Project: Cyril Le Marquand House Office Accommodation Project

Drawing title: Reflected Ceiling Plan - Level 01

Job No.: 3979 | Drawing No.: OAP-AXM-XX-01-DR-A-3501 | Revision: 15

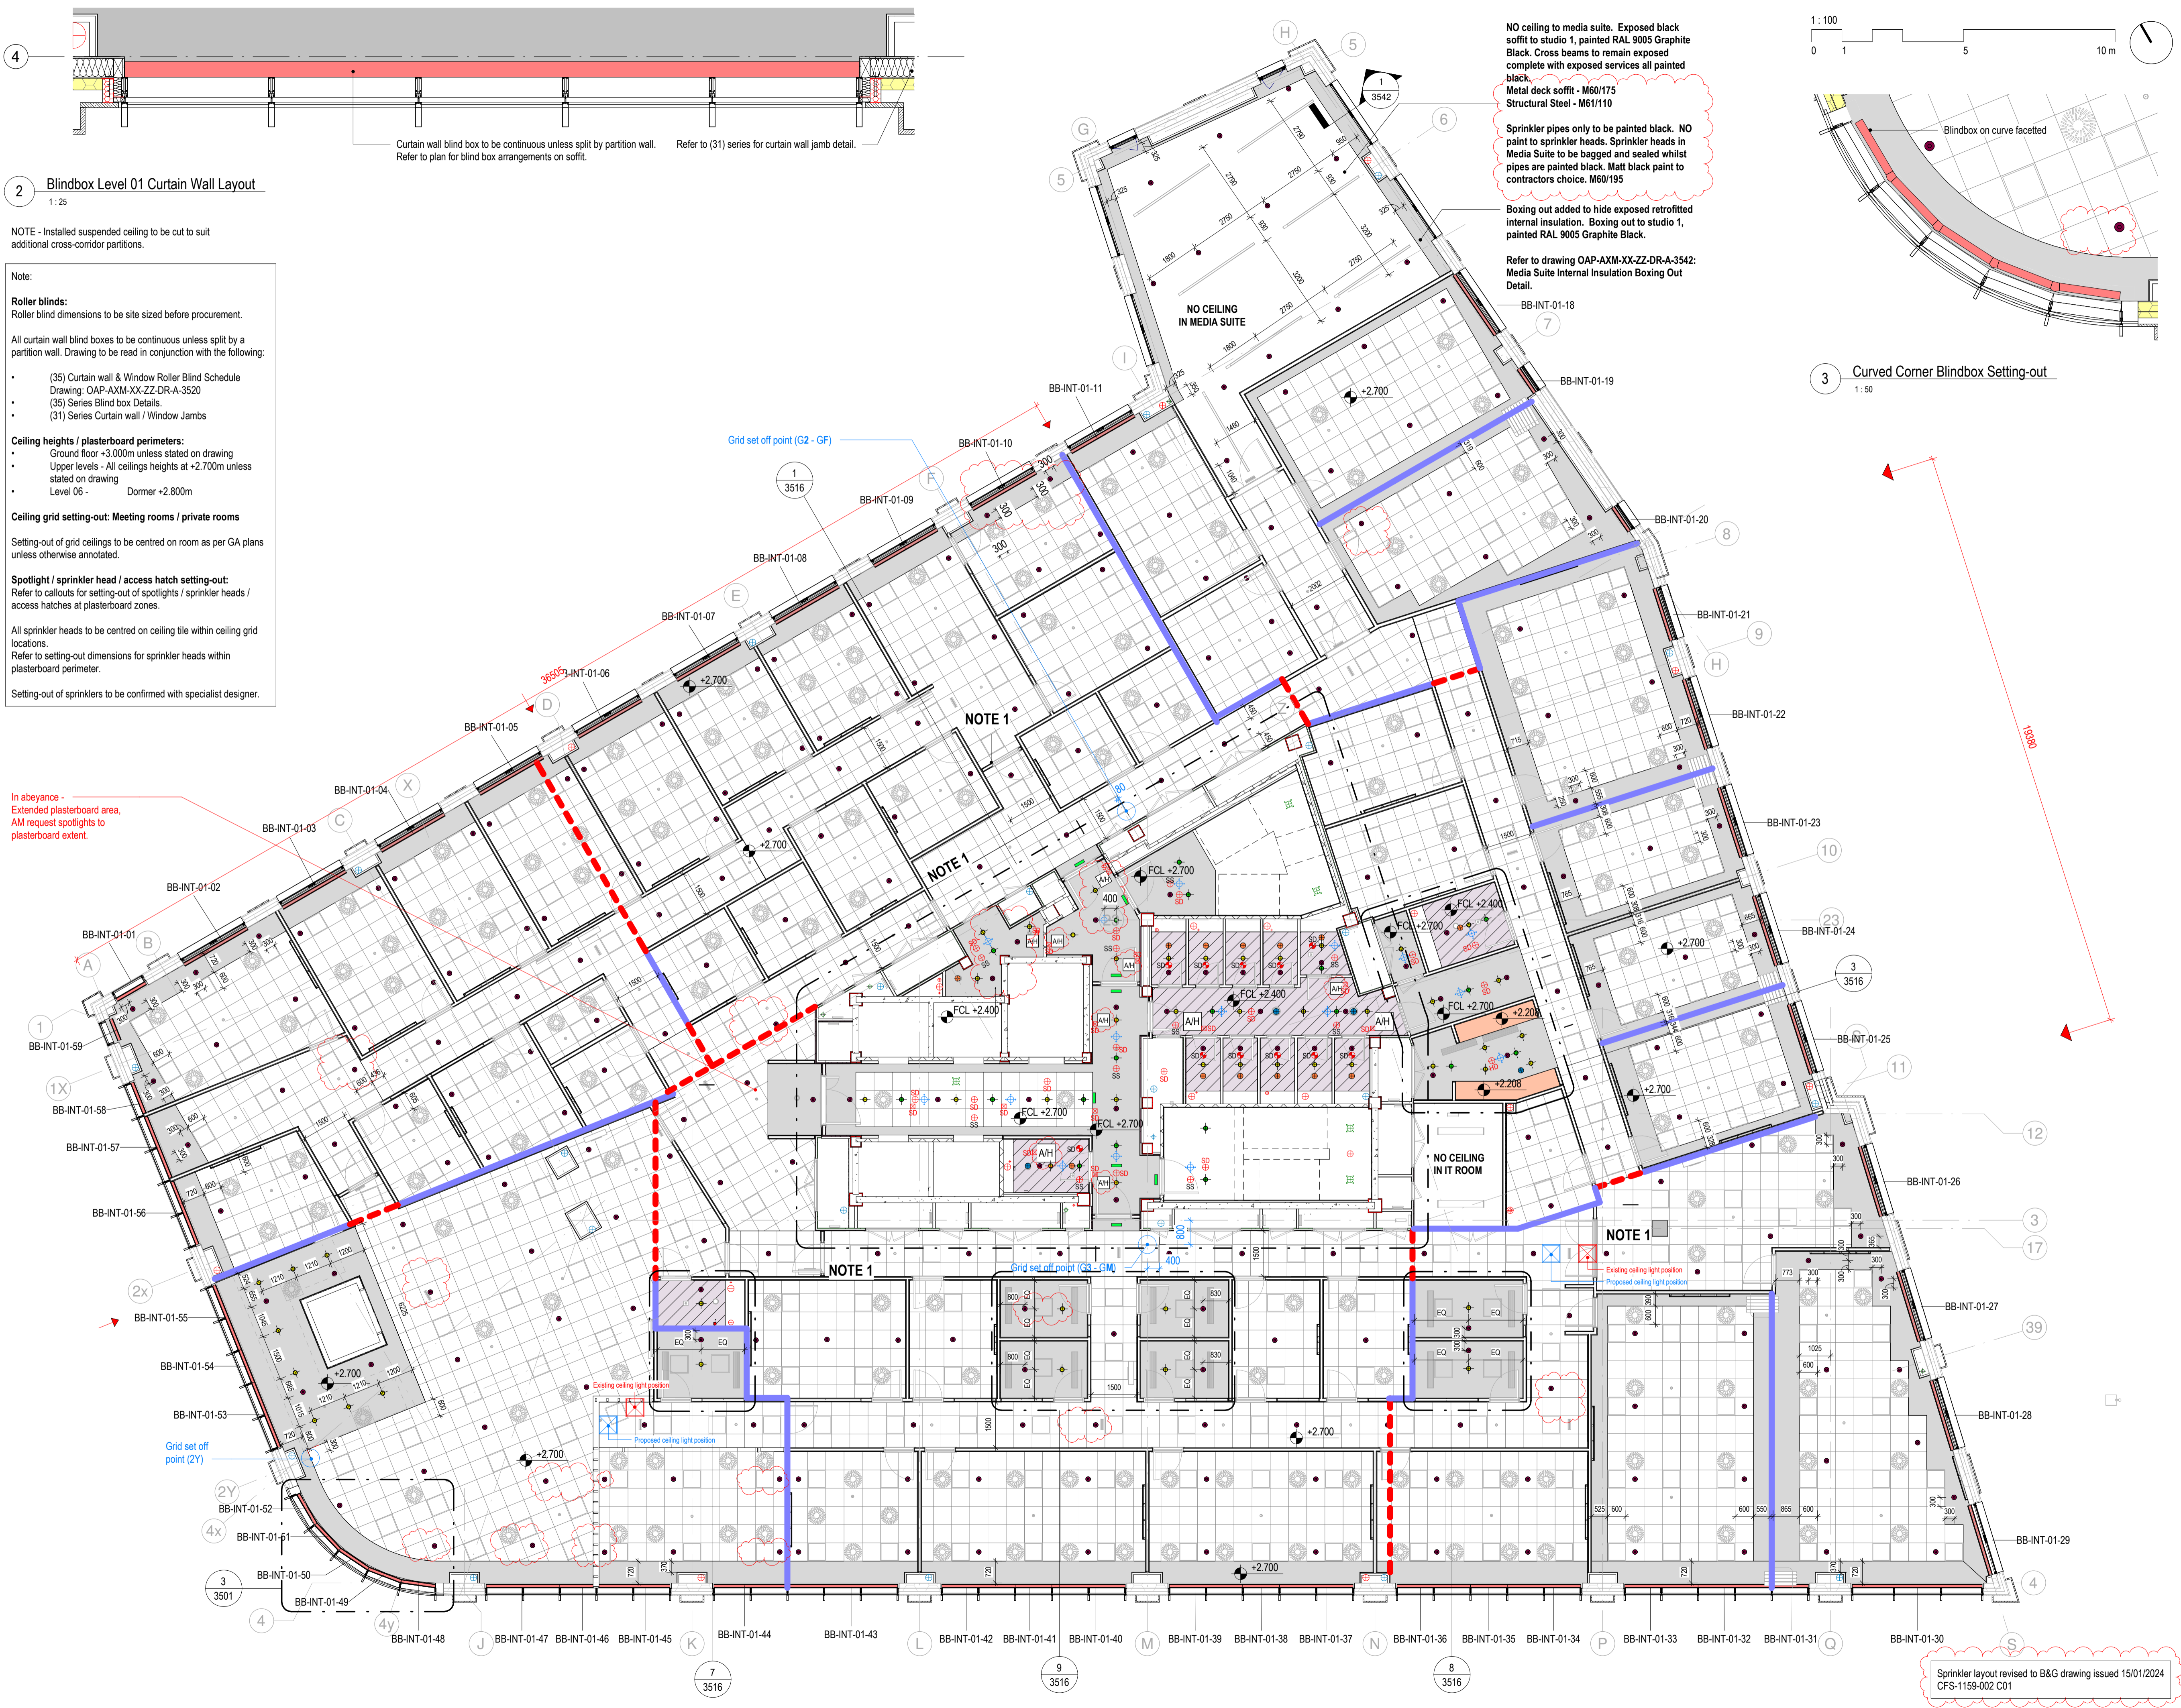
| Rev | Description | Dwn | Ckd | Date |
|-----|--|-----|-----|----------|
| 14 | Colour to Media Suite exposed soffit / structural beams updated to RAL 9005 graphite black in accordance with VR 33. All revisions have been included in red. | AMc | KM | 08.01.24 |
| 15 | Sprinkler layout revised to B&G layout. Ceiling access hatches added to drawing. All revisions included in red. | AMc | CvD | 07.02.24 |

Sprinkler layout revised to B&G drawing issued 15/01/2024 CFS-1159-002 C01

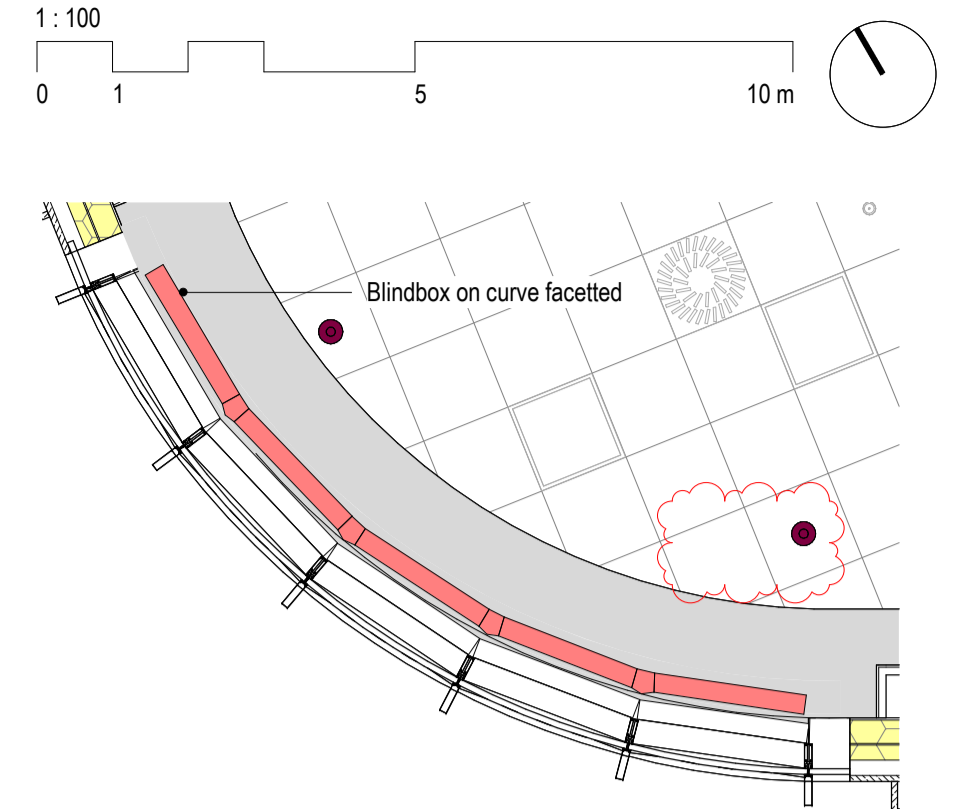
NO ceiling to media suite. Exposed black soffit to studio 1, painted RAL 9005 Graphite Black. Cross beams to remain exposed complete with exposed services all painted black.
Metal deck soffit - M60/175
Structural Steel - M61/110

Sprinkler pipes only to be painted black. NO paint to sprinkler heads. Sprinkler heads in Media Suite to be bagged and sealed whilst pipes are painted black. Matt black paint to contractors choice. M60/195

Boxing out added to hide exposed retrofitted internal insulation. Boxing out to studio 1, painted RAL 9005 Graphite Black.
